Virgil C. Summer Nuclear Station (VCSNS) Units 2&3
Combined License Nos. NPF-93 and NPF-94
Docket Nos. 52-027 & 52-028

Subject: LAR 17-03: VCSNS Units 2&3 Request for License Amendment and
Exemption: Hydrogen Venting from Passive Core Cooling System (PXS)
Compartments

**Request for License Amendment,
Hydrogen Venting from Passive Core Cooling System (PXS) Compartments
(LAR 17-03)**

Figure 3-1
Component Layout for Temperature Distribution

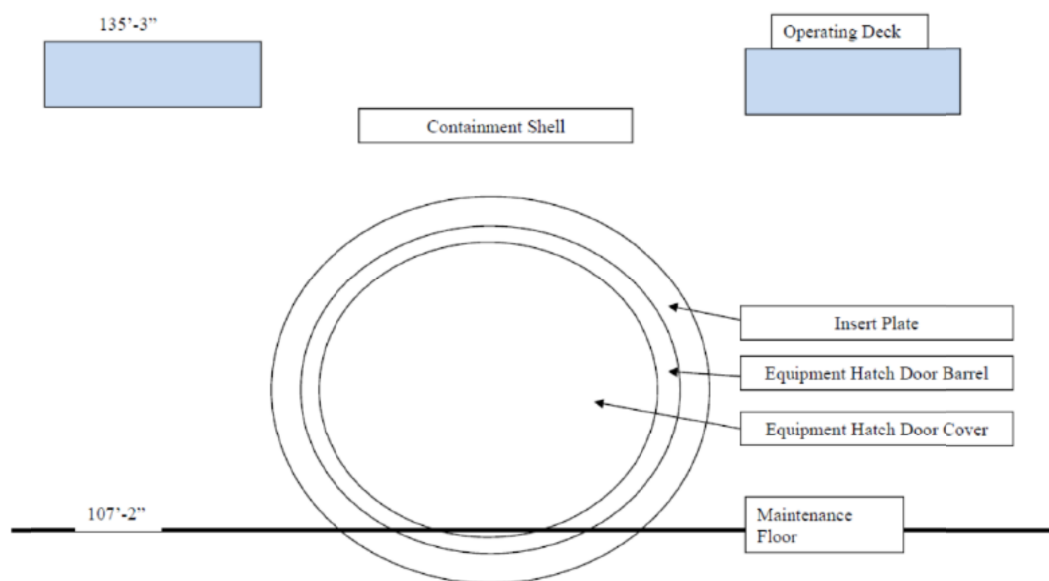
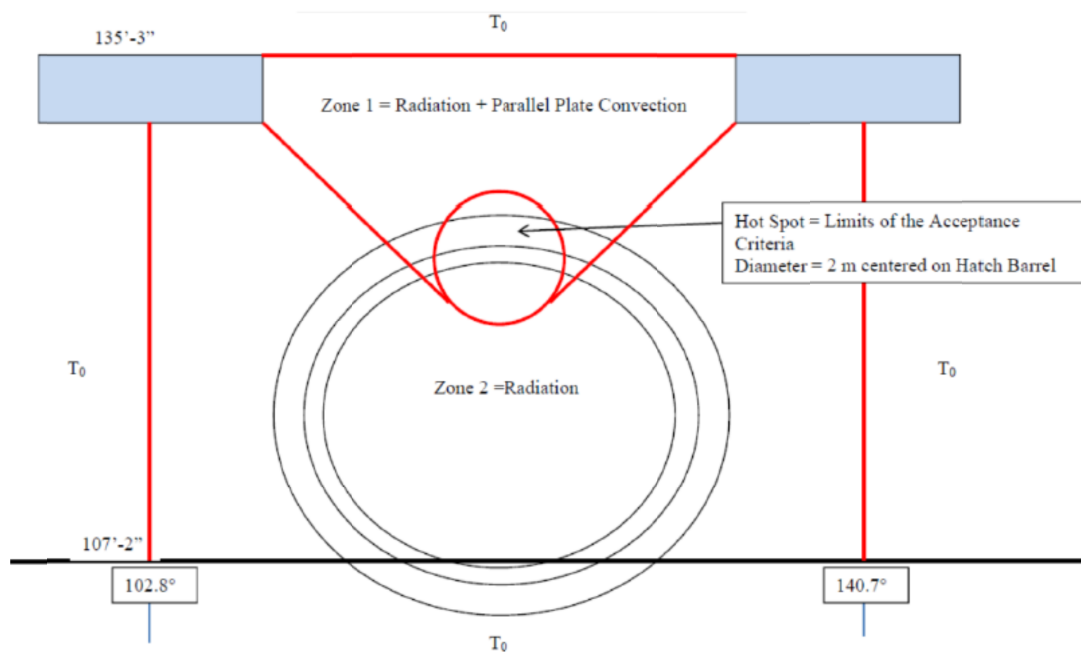
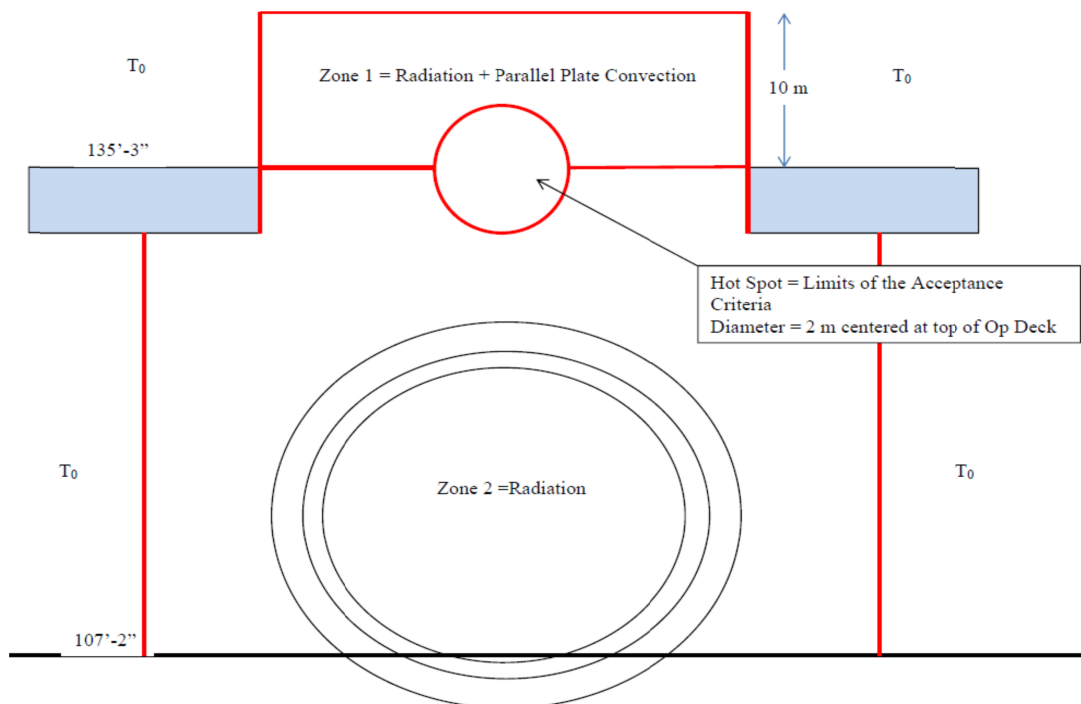
A one-dimensional heat transfer calculation was performed to evaluate temperature distribution on the containment vessel resulting from the diffusion flame hydrogen burn. A CFD analysis was also performed. Insights from the CFD analysis are only used if they point to a non-conservative assumption. Given the nature of the modelling, the flame can only be modelled at each vent location individually. The results of the one-dimensional calculation and the CFD model show the equipment access opening produces the highest temperature on the containment shell and equipment hatch. The analysis created two temperature distributions. The first distribution assumed that the plume creates a hot spot that spans the hatch cover, hatch barrel, insert plate and containment shell. The second distribution was developed based on the insights from the CFD analysis in which the hot spot occurs on the containment shell at the vent exit.

The hot spot is the local area where the burning plume flow impacts the containment pressure boundary. The heat transfer consists of radiation heat transfer and horizontal (flat plate in cross flow) and vertical (flat plate in parallel flow) convection. For the structural analysis, the surface temperatures within the hot spot are the bounding temperature limits of the containment shell and the hatch door cover. For the hatch barrel hot spot temperature, where the hatch seals are located, the average wall temperature was calculated and the corresponding surface temperature is reported. Zone 1 is the area of the containment pressure boundary above the hot spot in contact with the plume that flows up the containment wall. The heat transfer consists of radiation heat transfer and vertical (flat plate in parallel flow) convection. Zone 2 is the area of the containment pressure boundary below the hot spot where the containment shell is not in contact with the plume flow but is receiving radiation heat transfer from the plume. The resultant temperatures are shown in the table and figures below.

In order to assess the integrity of the containment vessel, these temperature profiles were used as inputs for structural analysis. The containment vessel and equipment hatch cover are SA738 Grade B steel. The hot spot area shown on Figure 3-2, above, is at the top of the equipment hatch and covers the hatch barrel. A finite element analysis was used to calculate the maximum resultant stress intensity corresponding to the hot spots on the equipment hatch. The maximum resultant stress intensity on the equipment hatch is 15.25 ksi which is below the ASME Service Level C limit of 63.6 ksi. Therefore, although at the hot spot the equipment hatch cover peak temperature (780°F) exceeds the maximum service level temperature (650°F), the maximum resultant stress intensity is less than the ASME Service Level C allowable limit and meets the Service Level C requirements of ASME Code, Section III, Division 1, and Subsection NE-3230.

Within the hatch barrel are EPDM rubber seals. The seals are exposed to a lower temperature than the hatch barrel surface because they are behind the equipment hatch; however, the seals exceed their design temperature of 300°F. The EPDM rubber compression set has been tested to temperatures beyond the design temperature for extended durations. Because the duration during which the seals are above their design temperature is low (less than 2 hours), the structural integrity of the seal is not compromised and there is reasonable assurance of the integrity of the seals at 390°F (for the inner seal ring the temperature is slightly above 390°F). Additional analysis was completed to evaluate the equipment hatch which experiences uneven heating due to the asymmetric thermal loading condition. This uneven heating could lead to potential distortion of the equipment hatch cover relative to the barrel flange and therefore the additional analysis determined whether this distortion could lead to potential leakage. The two rubber seals inside the flange function to prevent leakage. These rubber seals are designed with a high temperature resistance and elasticity. Based on this design, as long as the bolts around the perimeter of the equipment hatch cover are not stressed and stretched beyond the acceptable recovery of the seals, there is no path for leakage. A Finite Element Model was used to evaluate this. The analysis concluded that the equipment hatch bolts remain in the elastic region and do not deform to distort the connection. There are non-uniform gaps which form in the equipment hatch joint but the gaps are smaller than the gap that the seals in the joint fill. There is no leakage through the equipment hatch. Therefore, the containment remains leak tight following a hydrogen burn at the vent openings in Rooms 11206 and 11207.

Based on the results of the analyses described above, it was determined that containment integrity is not challenged due to diffusion flames resulting from a hydrogen burn at the vent openings from Rooms 11206 and 11207 to Room 11300.
